UNITED STATES
NUCLEAR REGULATORY COMMISSION
WASHINGTON, D.C. 20555-0001

July 11, 2017

SUBJECT: SOUTH TEXAS PROJECT, UNITS 1 AND 2 - ISSUANCE OF AMENDMENTS
RE: CHANGES TO DESIGN BASIS ACCIDENT ANALYSIS USING A
RISK-INFORMED METHODOLOGY TO ACCOUNT FOR DEBRIS IN
CONTAINMENT (CAC NOS. MF2400 AND MF2401)

Figure 1. STPNOC's RoverD Flow Chart

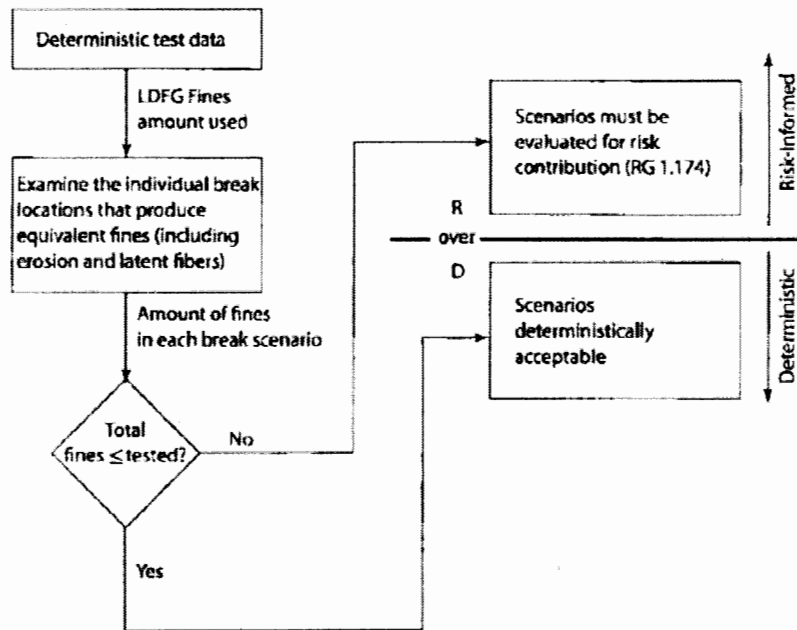
The RoverD methodology evaluated a deterministic category of failures in which the amount of debris [referred to as LDFG (low density fiberglass) fines in Figure 1, or fiber fines] known to cause sump strainer clogging following a LOCA were equal to or less than the amount of debris used in the plant-specific testing for STP. The STPNOC testing used NRC-approved methods to establish an ECCS strainer debris load above which loss of function may occur. This is represented by 'Deterministic test data' in Figure 1. See discussion in SE Section 3.4.2.8.3, "Head Loss and Vortexing," for details on the STPNOC deterministic testing.
